Urgent Field Safety Notice

794400008

XQ series: Incorrect WBC result output to the host computer

Product Name	XQ-320; XQ-520
Product Description	XQ-Series Automated Hematology Analyzer
Affected Serial No	all
Type of Action	Advice given by manufacturer regarding use of the IVD
FSCA-identifier	794400008

Figure 2: Example screenshot of affected settings – the issue does occur.

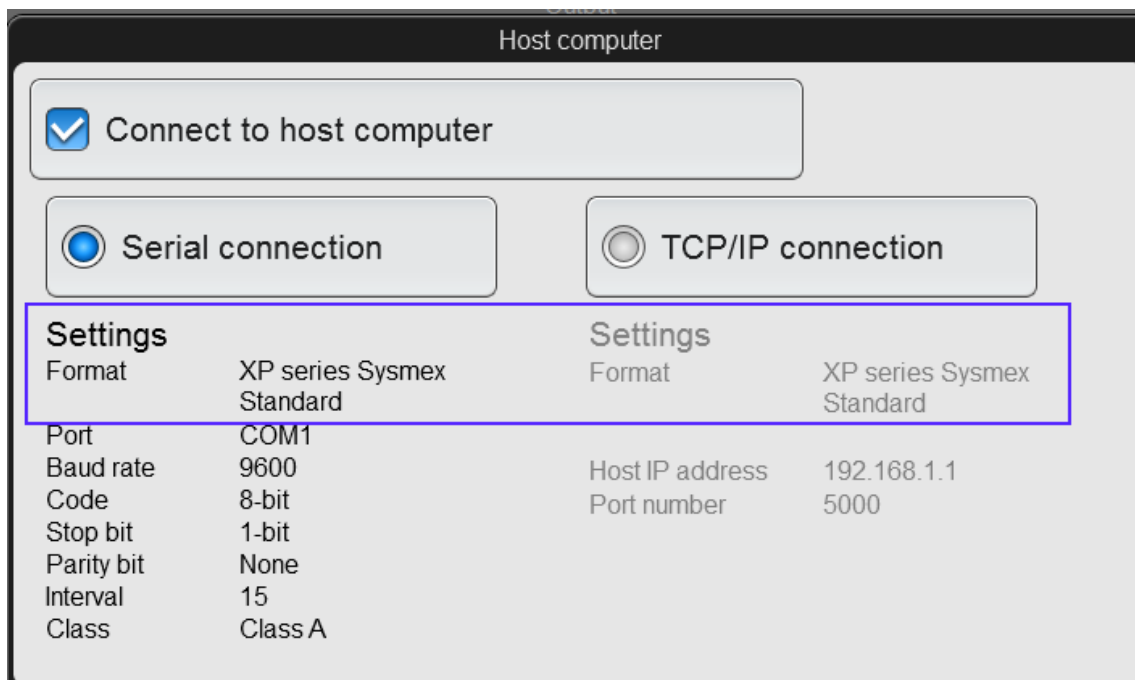
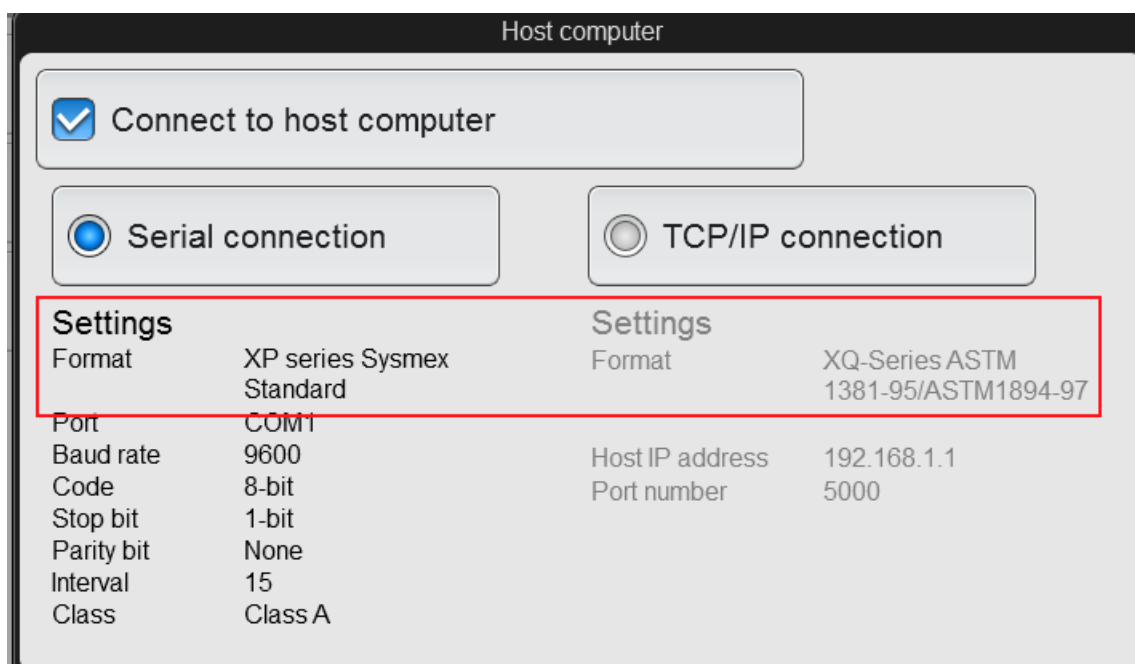
WBC value results transmitted from the analyser to a host computer are 10 times higher than the correct results displayed on the analyser screen.

This malfunction occurs only when you use a serial connection and a legacy data transfer format (KX21N or XP series standard) and is caused by the **[Serial connection]** and **[TCP/IP connection]** settings not matching. Due to a software bug, the host format setting selected for TCP/IP is used, even when a serial connection is used.

Figure 3: Example screenshot of the host computer settings with a matching [TCP/IP setting] and data format of [Serial connection].

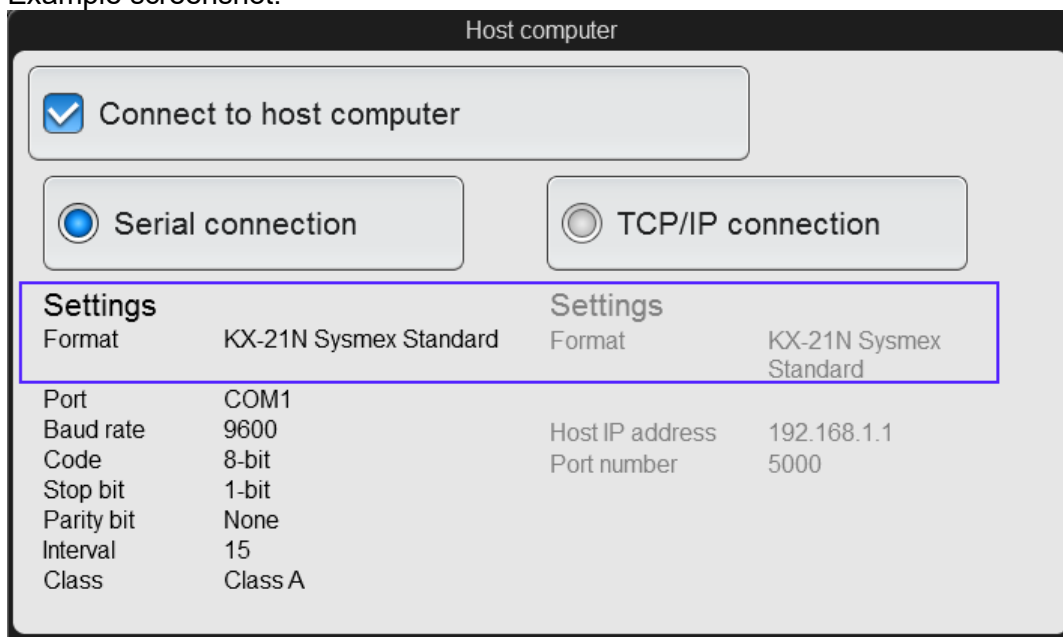
1. Confirm whether the WBC results in the analyser software and in the LIS on the host computer match.
2. If WBC results do not match, that is, if WBC results on the host computers are higher by a factor of 10, change the host computer setting. The data format of **[TCP/IP connection]** must be the same as the data format of [Serial connection].
